CITY OF ALBUQUERQUE

Re: Magnum Builders
6623 Rimrock NE, SAD 227 Lot 7, Block 1 Volcano Cliffs
Request Permanent C.O. – Not Accepted
Engineer's Stamp dated: 9-18-17 (D10D010)
Certification dated: 3-6-18

DRAINAGE AND TRANSPORTATION INFORMATION SHEET (REV 09/2015)

ENGINEER'S SEAL 9/8/17 DAVID SOULE P.E. #14522	6623 RIM ROCK	DRAWN BY WCWJ
	GRADING AND DRAINAGE PLAN	DATE 9-07-17
 Rio Grande Engineering 1806 CENTRAL AVENUE SE SUITE 201 ALBUQUERQUE, NM 87106 (505) 872-0899		21795-LAYOUT-9-07-17
		SHEET #
		JOB # 21795

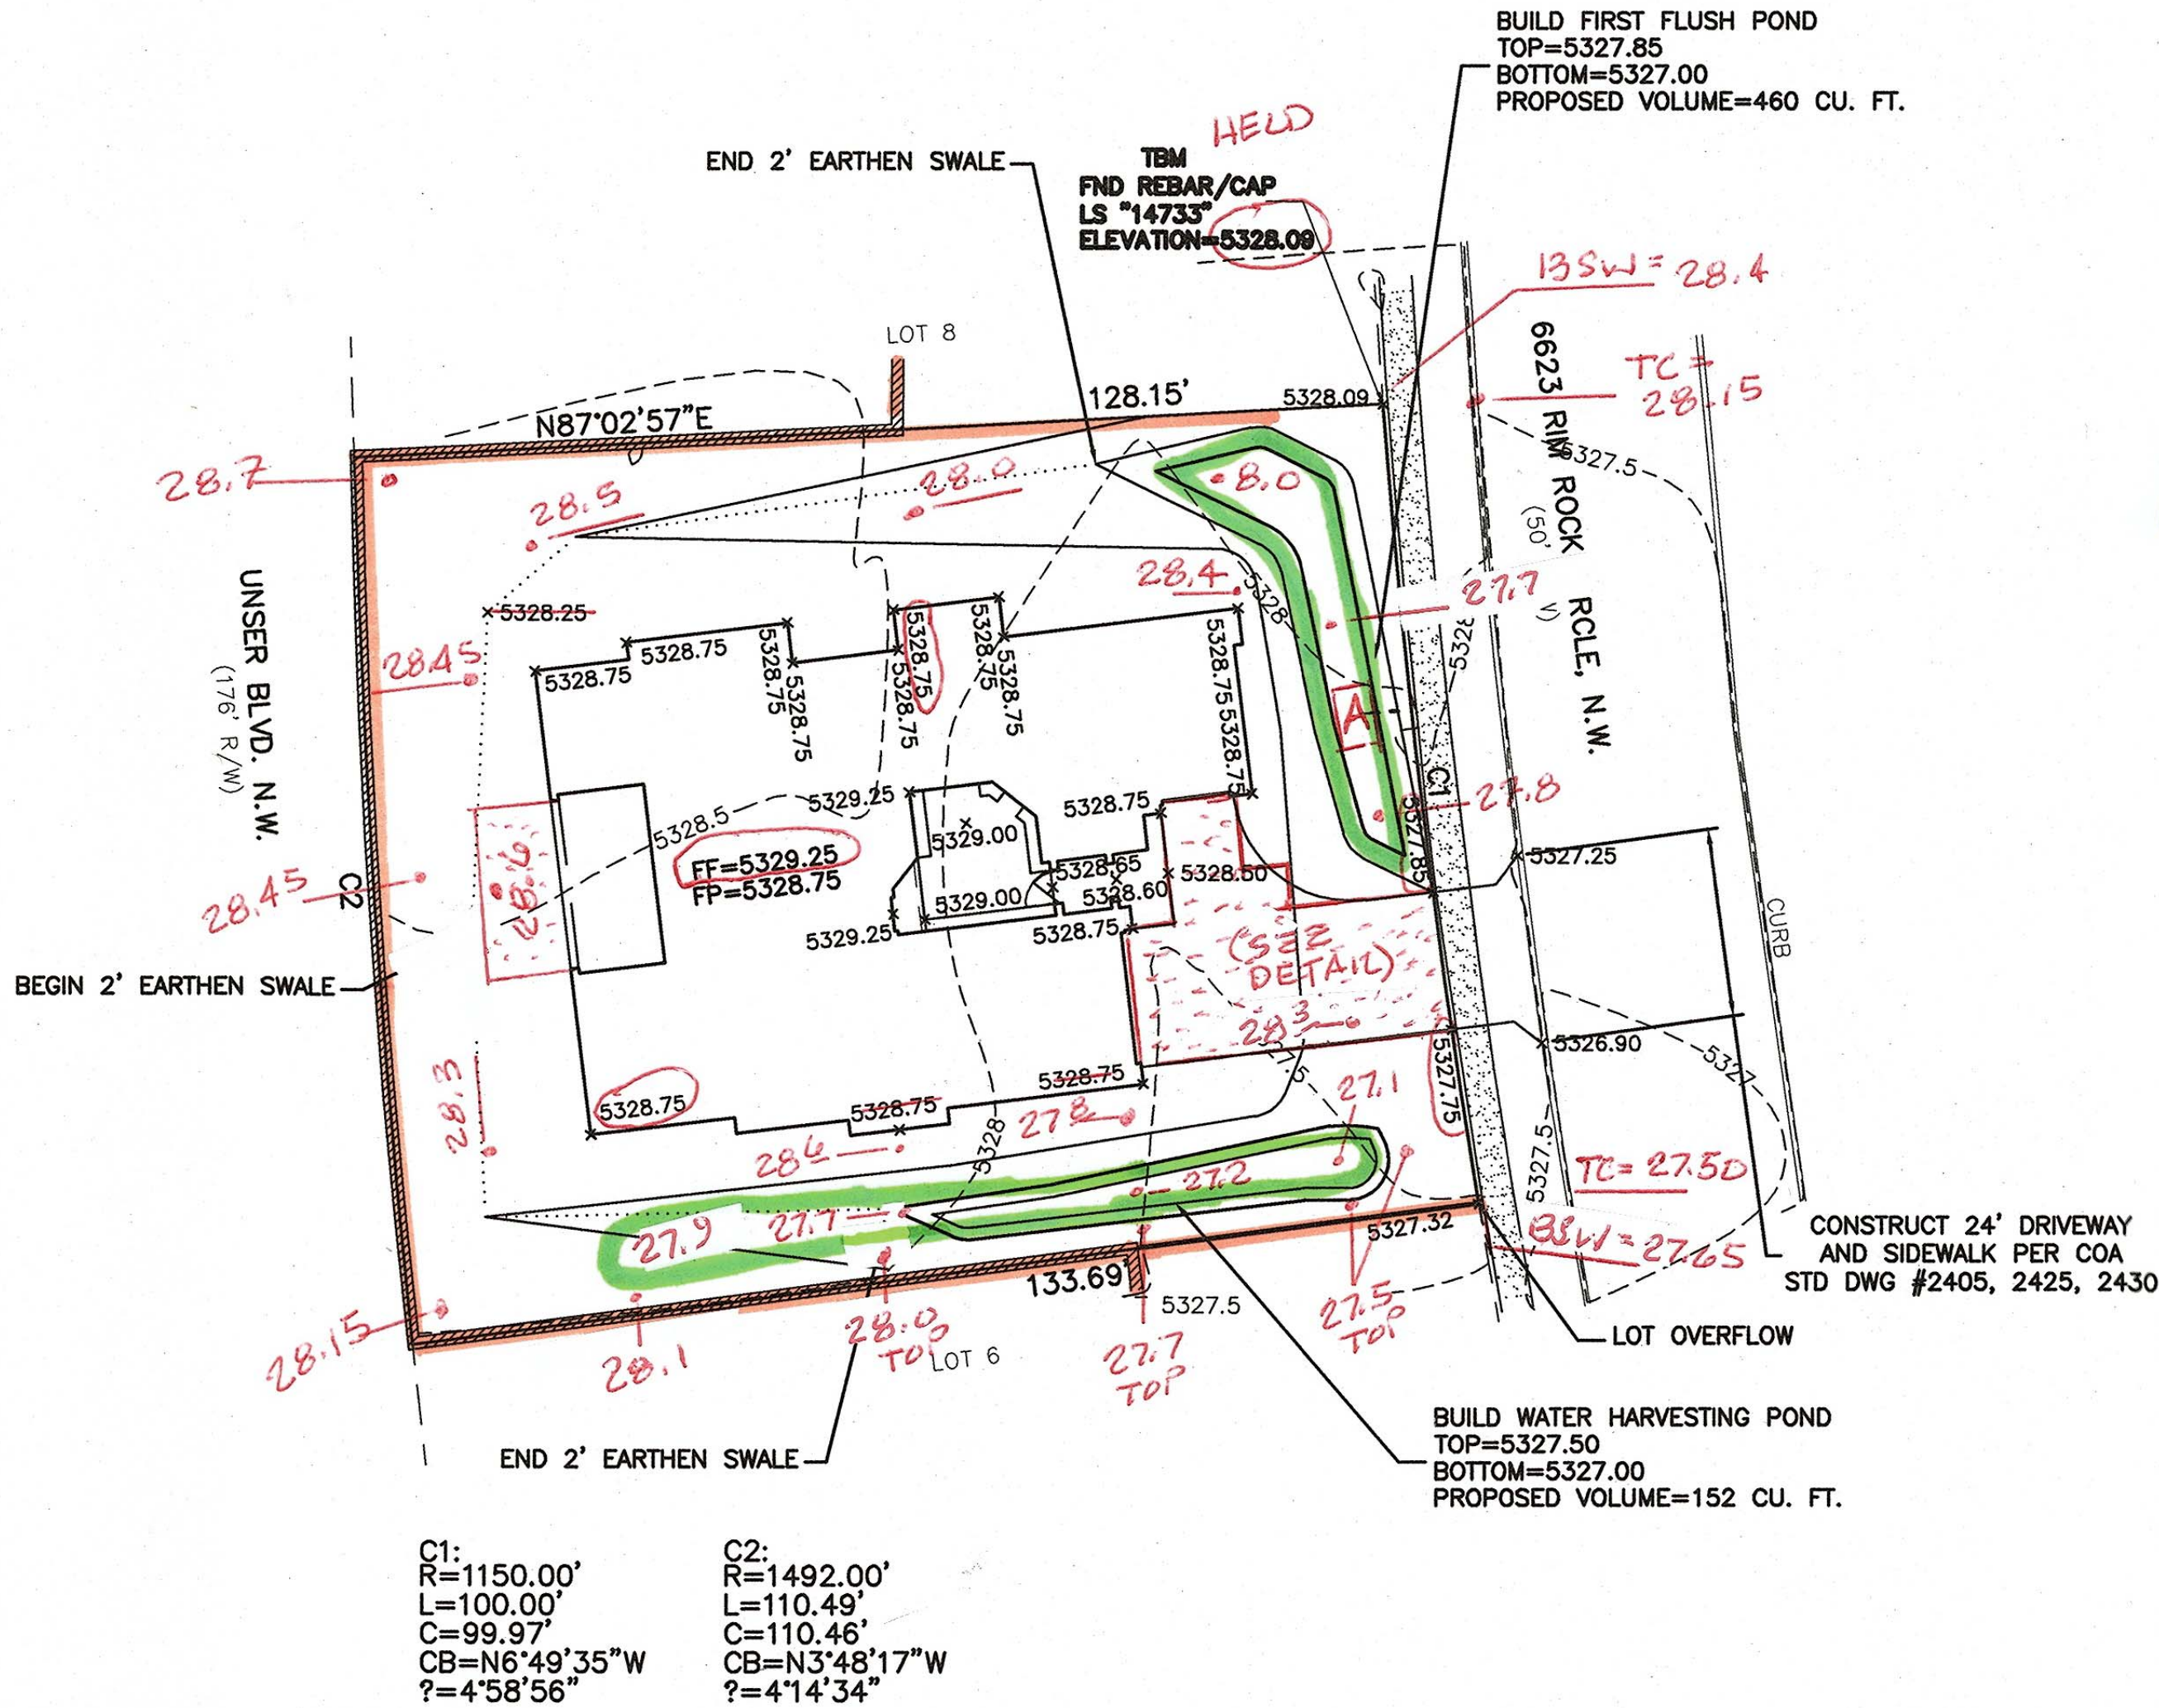
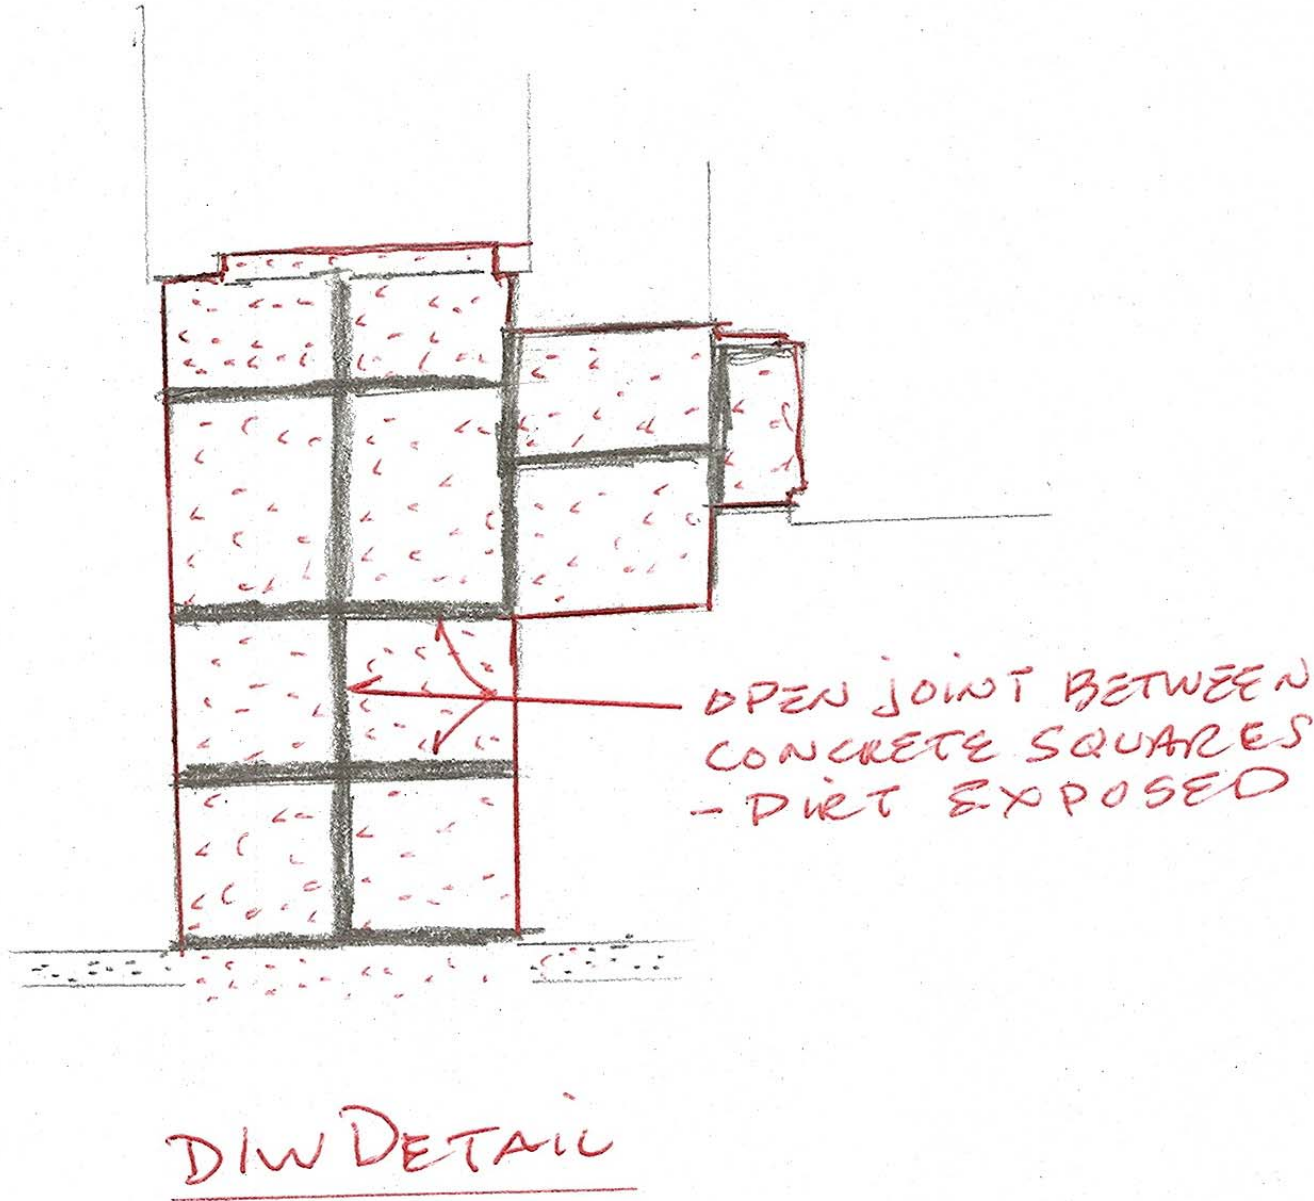
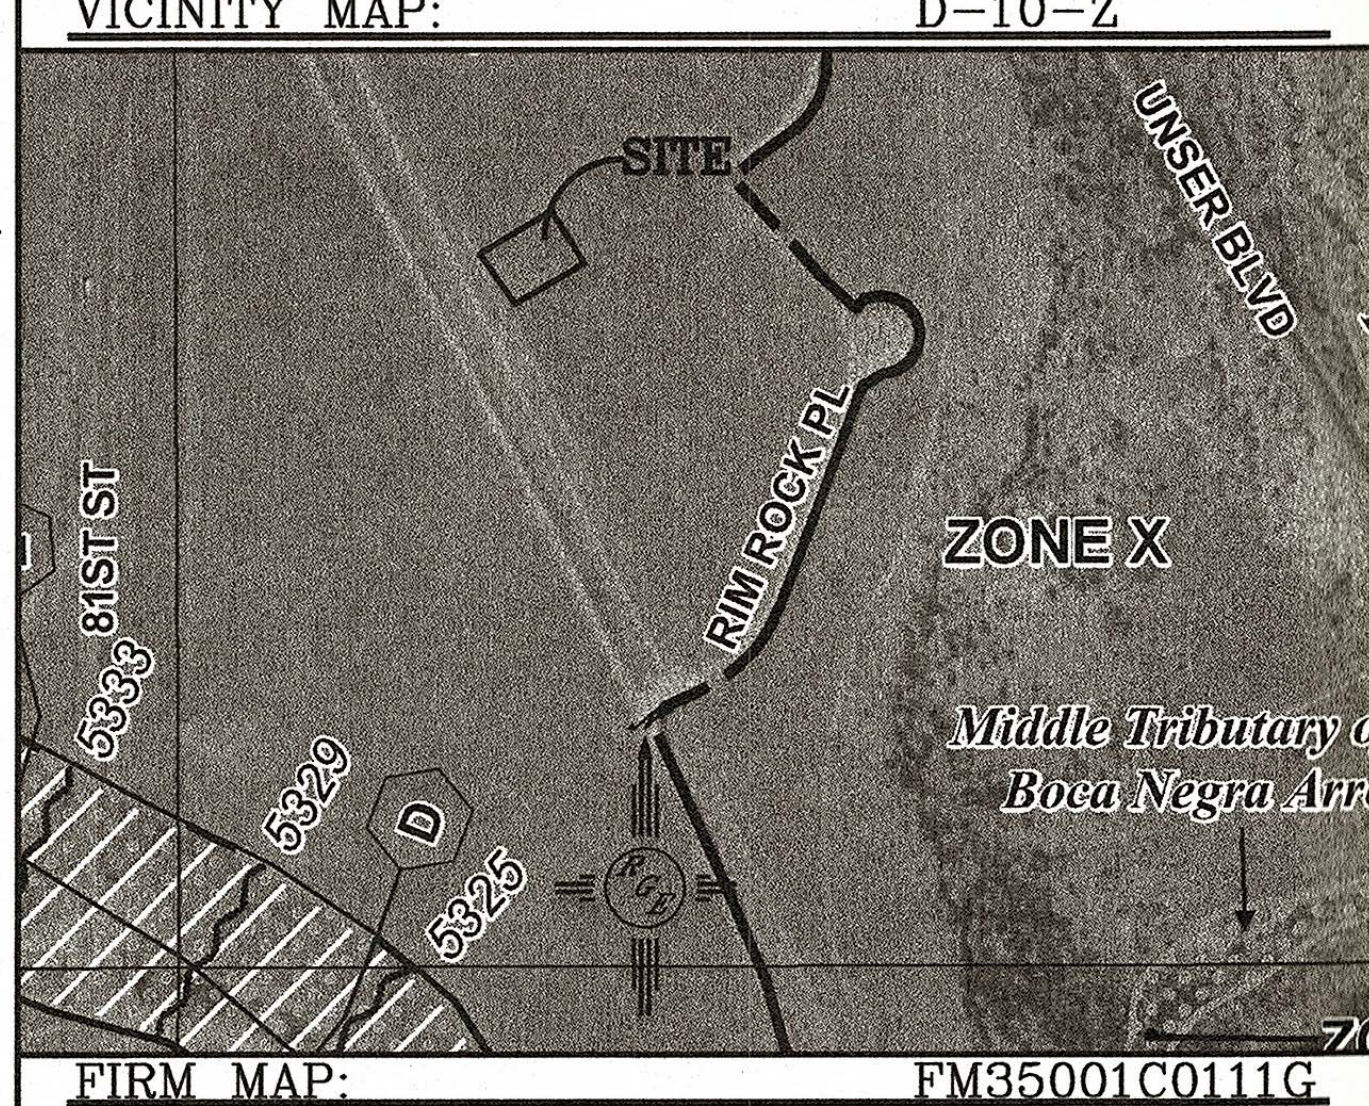
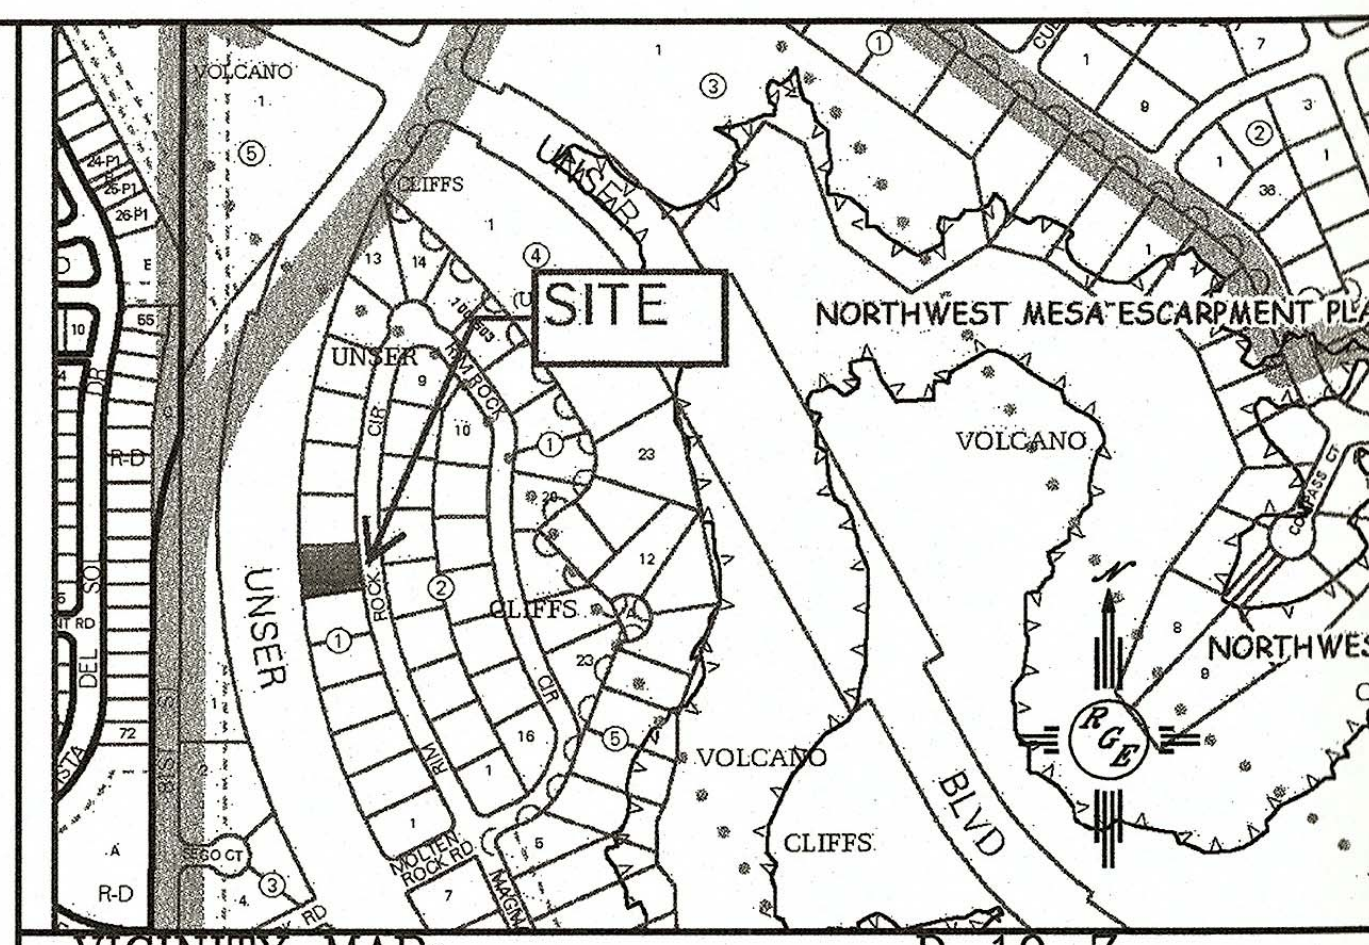
Based on the Certification received 3/8/2018, the site cannot be accepted for release of Certificate of Occupancy by Hydrology until the following comments are addressed.

- Remove the dirt piles and debris in and around the site.
- What is the purpose of the 3" pipe coming from under the home?
- Provide how flows escape the atrium/open area near the front door.
